City of Richmond
Urban Development Division

Report to Committee

RZ 04-276170

Re: **Application by Jacken Investments Inc. for Rezoning at 11351, 11391, 11411, 11431, 11471 and 11491 Steveston Hwy. from Single-Family Housing District, Subdivision Area E (R1/E) to Townhouse District (R2-0.6)**

FIRE FIGHTING PLAN

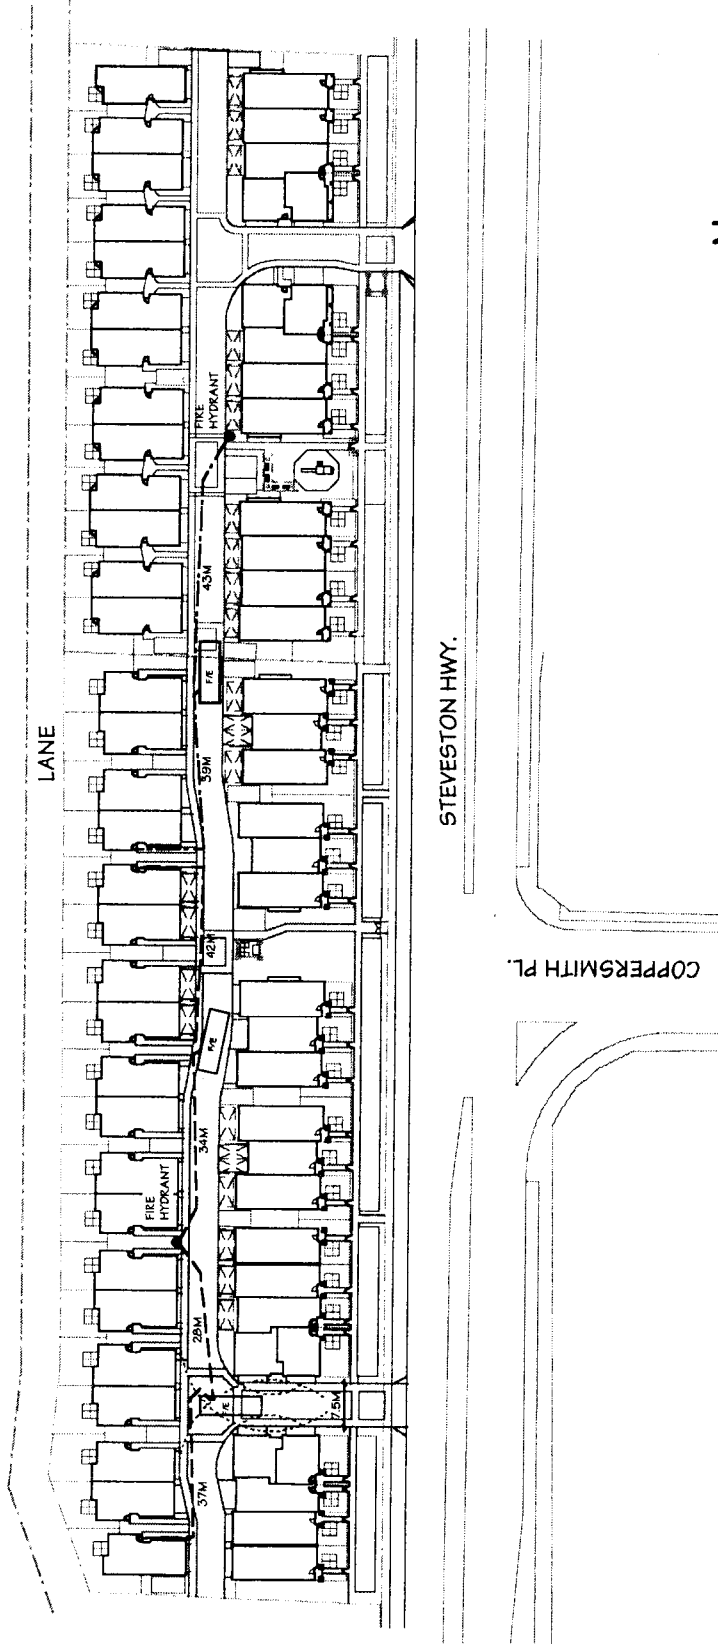
6. For the development permit, smoothen the transition of the drive aisle and demonstrate how loading truck (i.e., SU-9) and fire truck could be accommodated on site. Show loading truck (SU-9) and fire truck turning paths on a scaled drawing.

The applicant has worked with Staff to adjust the plans and address issues raised during the technical review. Adjustments were made to the design, for example, to accommodate turning radii needed for Fire Department vehicles to access the site. The applicant has worked closely with Fire Department staff to design a workable fire fighting plan for the site.
